From: Bob Gorski, PE, Cliff Koenig, PE, Dave Traeger, HDR

Subject: Waste Management Countryside Landfill Odor Investigation

Project: Task Order # 2 Project No: 100385

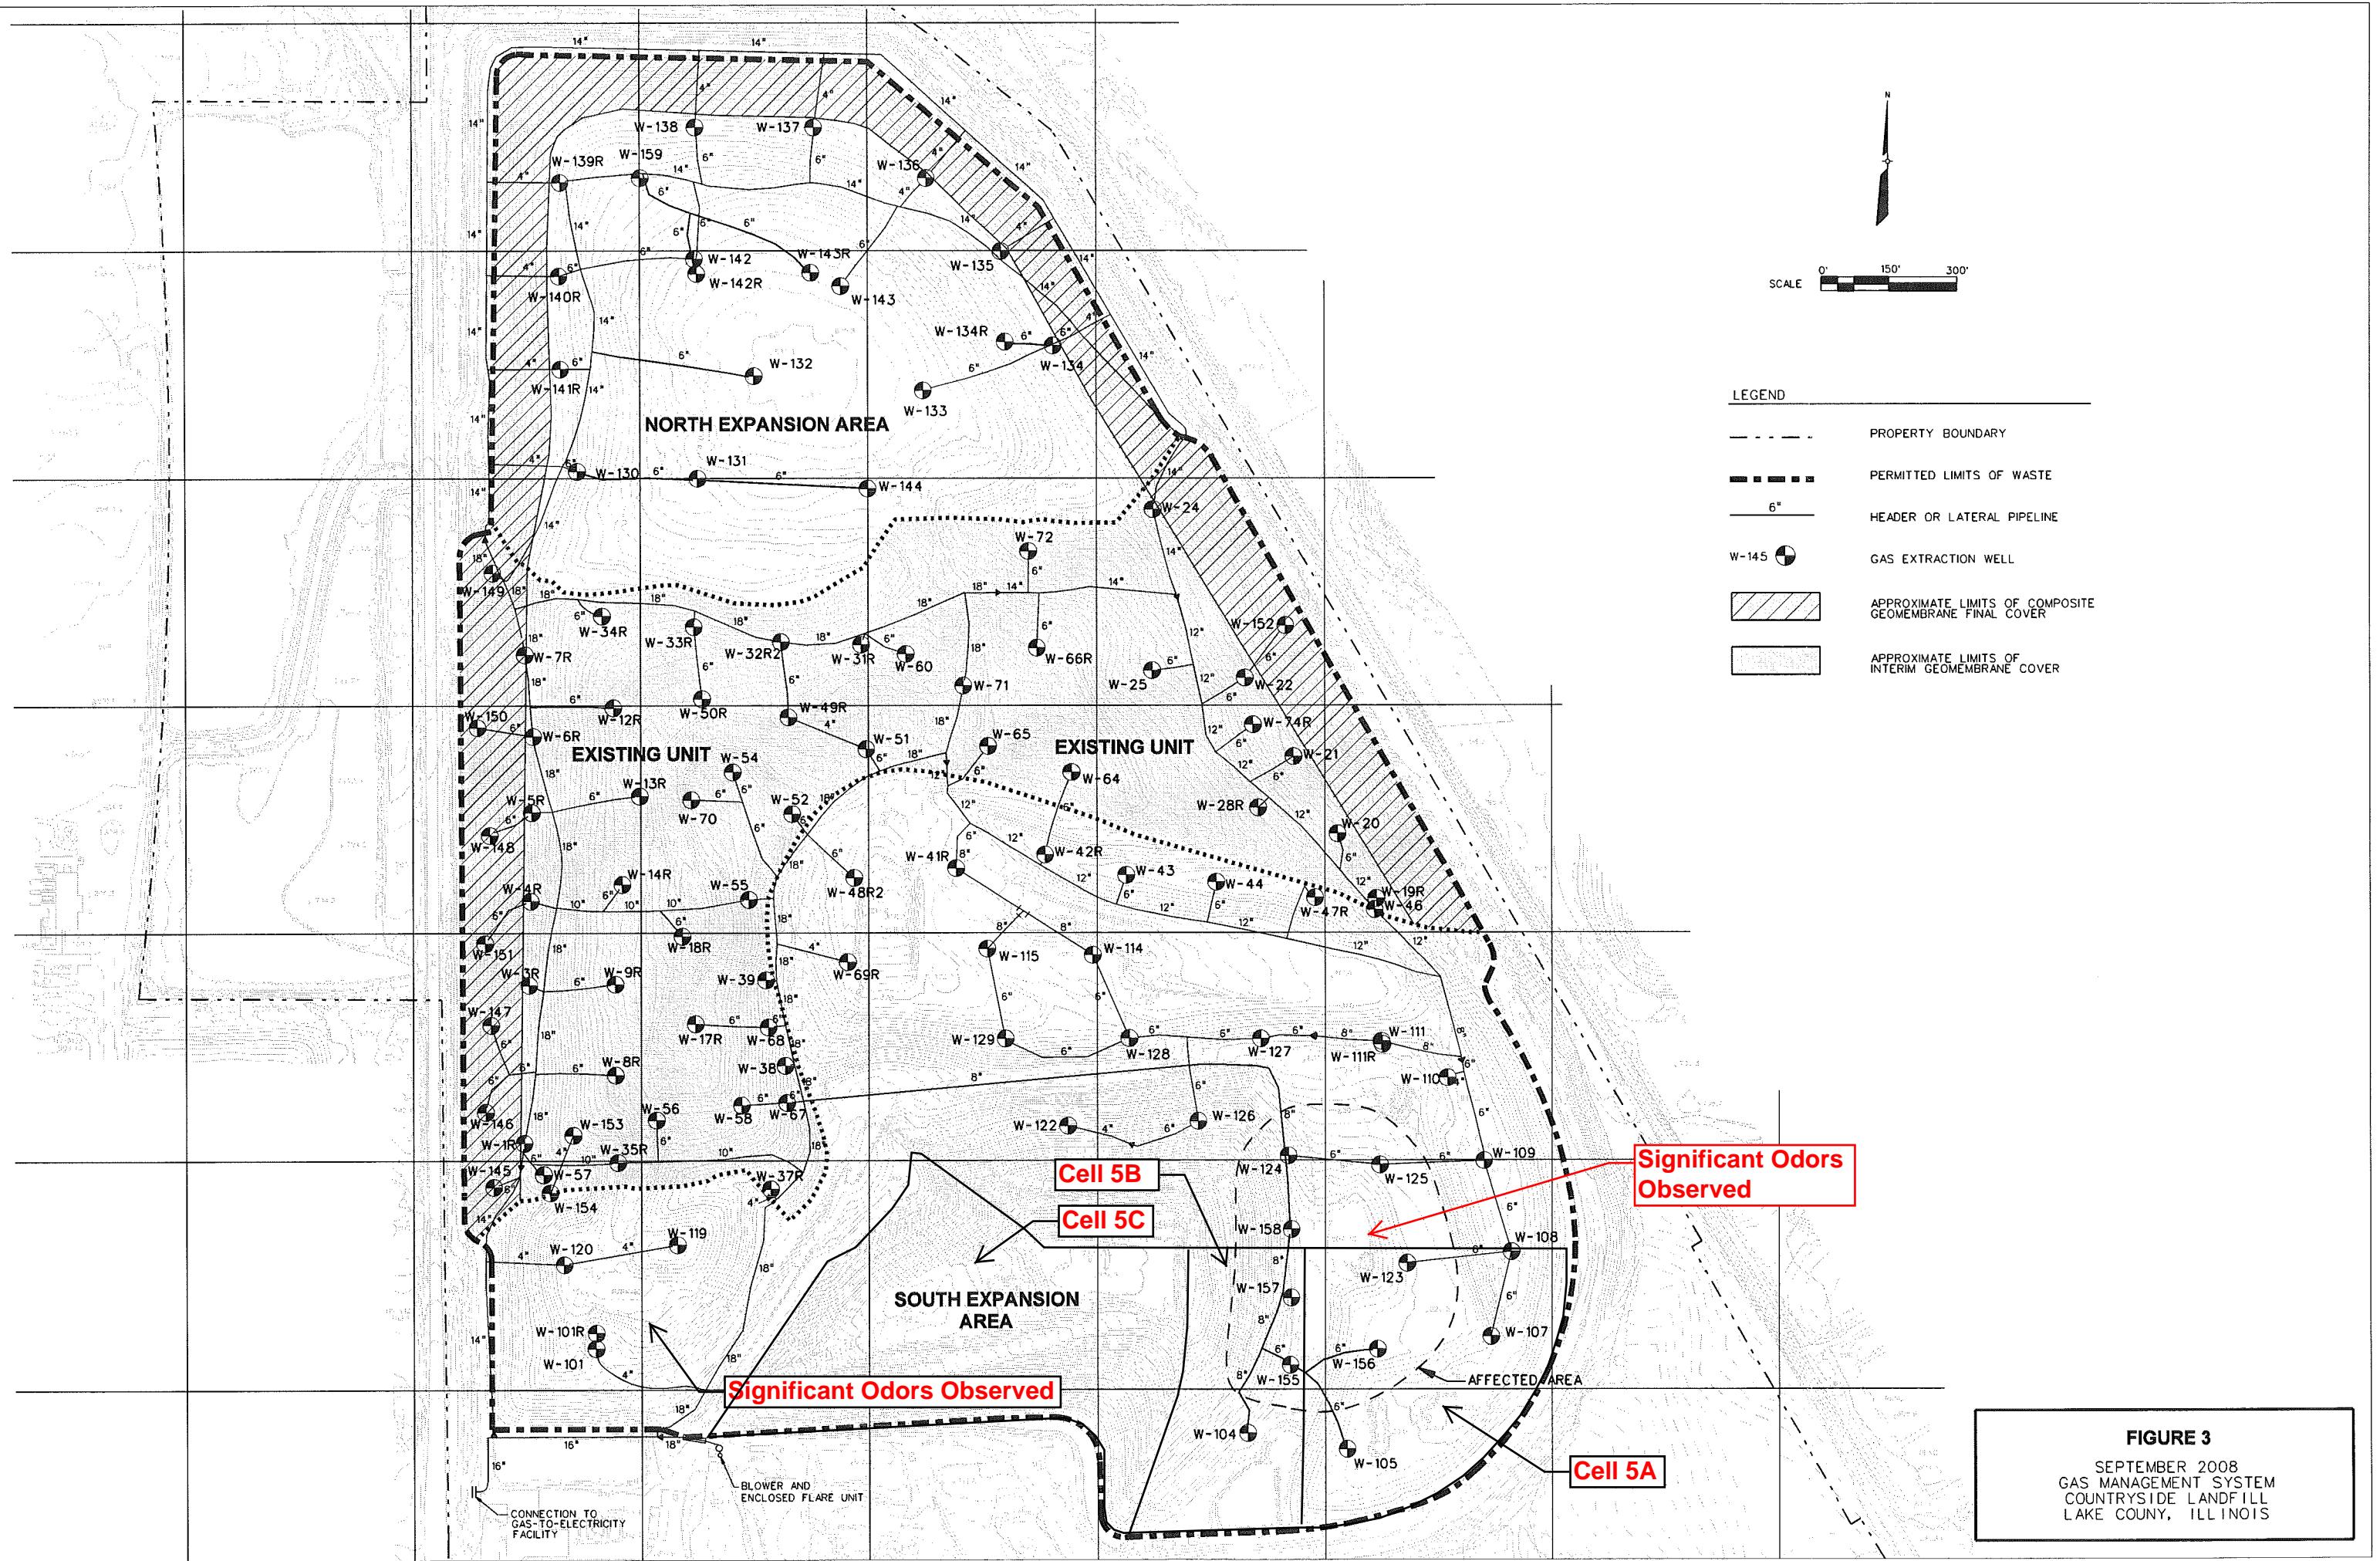
4. **Landfill Gas Collection System:** WM currently has an active landfill gas collection system in place at the Countryside Landfill. The attached Figures 2, 3 and 4 illustrate the gas collection system reviewed for the odor investigation. The active gas collection system pulls gas from the landfill and directs to either a flare for combustion or to a LFGTE facility adjacent to the site. If properly designed, built and operated, this active gas collection system should serve as the primary system for gas emission and odor control. As illustrated in Figure 2, prior to the time of the odor complaints (summer of 2008) only three wells (123, 124 and 125) were installed and operating in the area Cell 5A, 5B, suspected to be the primary source of odor emissions. WM has subsequently installed an additional 17 wells in the vicinity of Cells 5A and 5B as shown on Figures 3 (September 2008 gas system expansion) and Figure 4 (December 2008 gas system

- September 2008 - wells 104, 105, 155, 156, 157, 158 and 159, as shown in Figure 3
- December 2008 - wells 201 through 208 and wells 212, 213 and one replacement well 111R, as shown in Figure 4

FIGURE 4

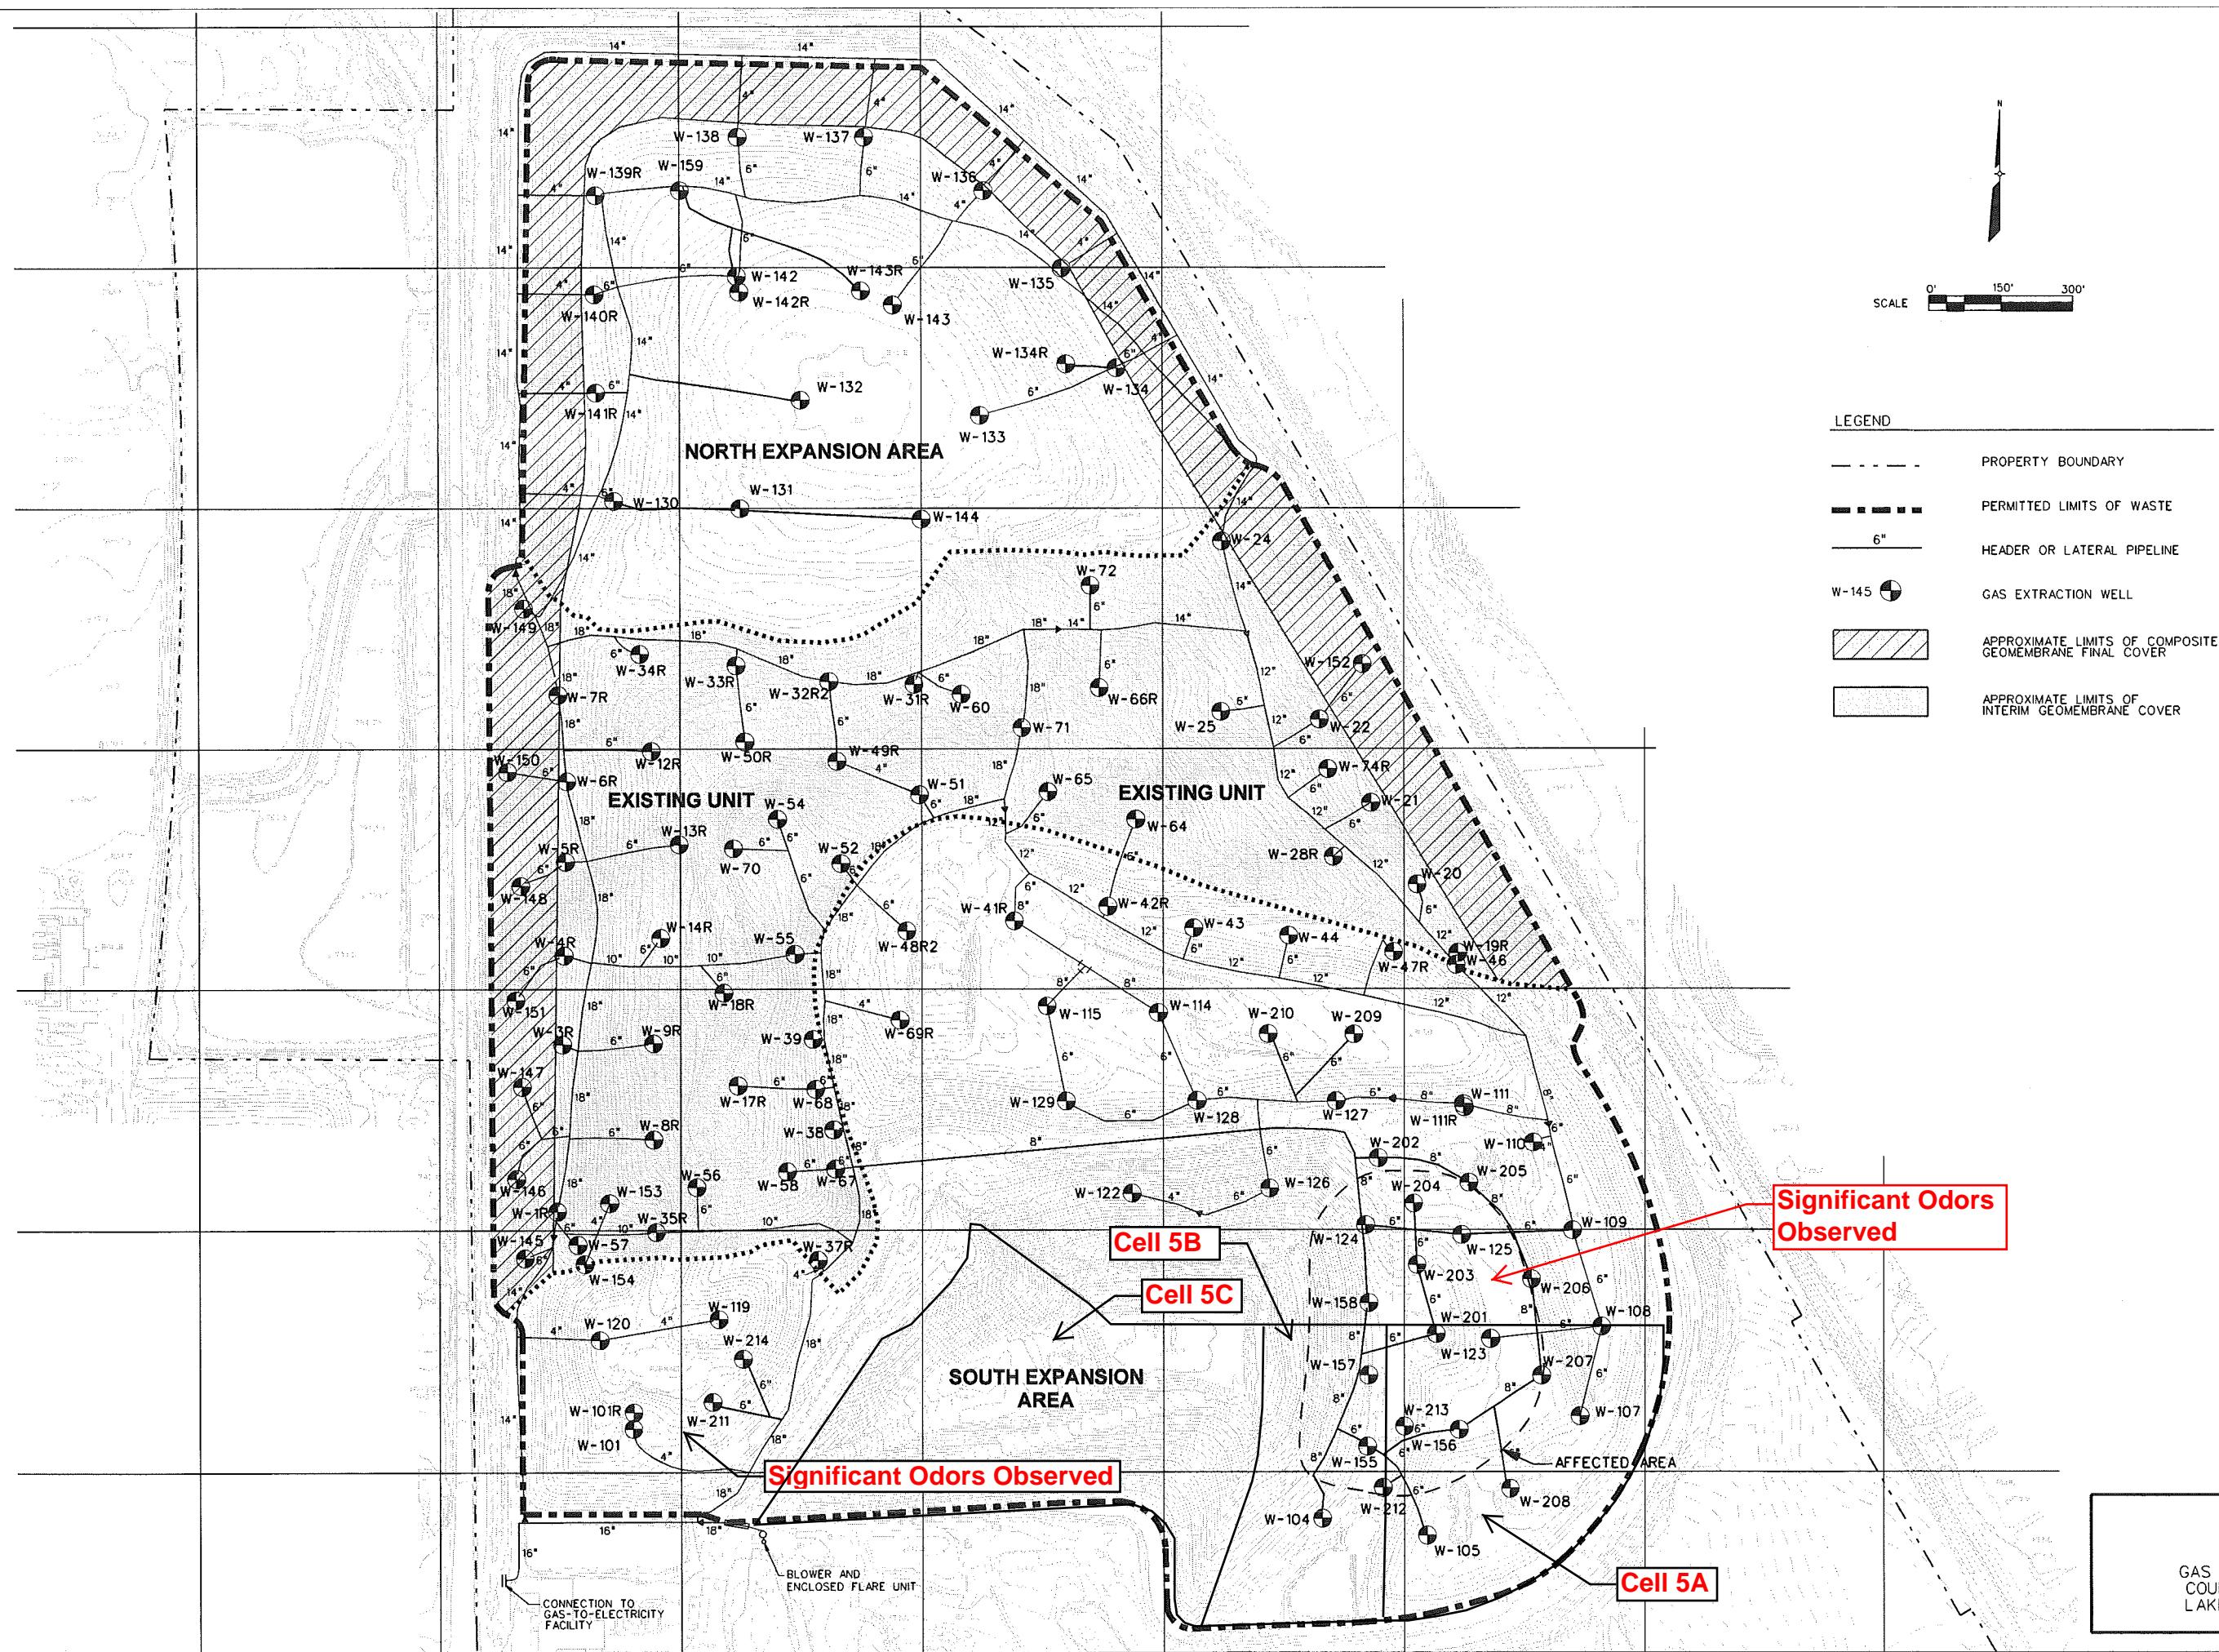
Based on conversations with WM, documentation provided by WM, and HDR's investigation, the odors leading to the complaints are originating from the Countryside Landfill and more specifically the southern portion of the landfill. Odors appear to be originating from portions of Cell 5A and Cell 5B. The specific areas of concern, identified by WM investigation, are shown as a dashed line in Figure 4, in Attachment A and located on Exhibit 1 in the vicinity of Cells 5A and 5B.

Because of the limited access and nature of the site visit it was not possible to physically review all areas of the site and no instrumentation was used by HDR to measure or quantify gas emissions. As such, HDR accepted WM's statements and data that the areas labeled as the "affected area" (shown by a dashed line on Figure 4), and the area near well 211 were in fact the primary source areas leading to off-site reports of odor.

As noted above, 3 wells (123, 124 and 125) were installed in the southeastern portion of the landfill in the summer of 2008. WM installed 7 wells in the apparent odor generation area in September 2008 with a spacing of 150-300 feet between wells. In response to further odor complaints, WM installed an additional 10 gas extraction wells in the apparent odor generation area in December 2008, resulting in a spacing of 100-200 feet between wells. Wells installed in September 2008 and most wells in December 2008 appear to be functioning; their level of effectiveness in odor control could not be assessed due to winter conditions.

- 9) The seals on new wells (especially, 202 through 210, 212 and 213) should be further evaluated (and if necessary upgraded) to ensure sufficient vacuum can be applied to the well to capture gas from within the entire projected radius of influence of the wells. If current seals are ineffective they should be repaired or modified. Examples of modifications might include installation of additional low permeability soil or an impermeable barrier (such as a synthetic liner) around top of the wells to improve well seals. For future well installation, WM should install 2-foot bentonite seals with hydration as specified by the material manufacturer.
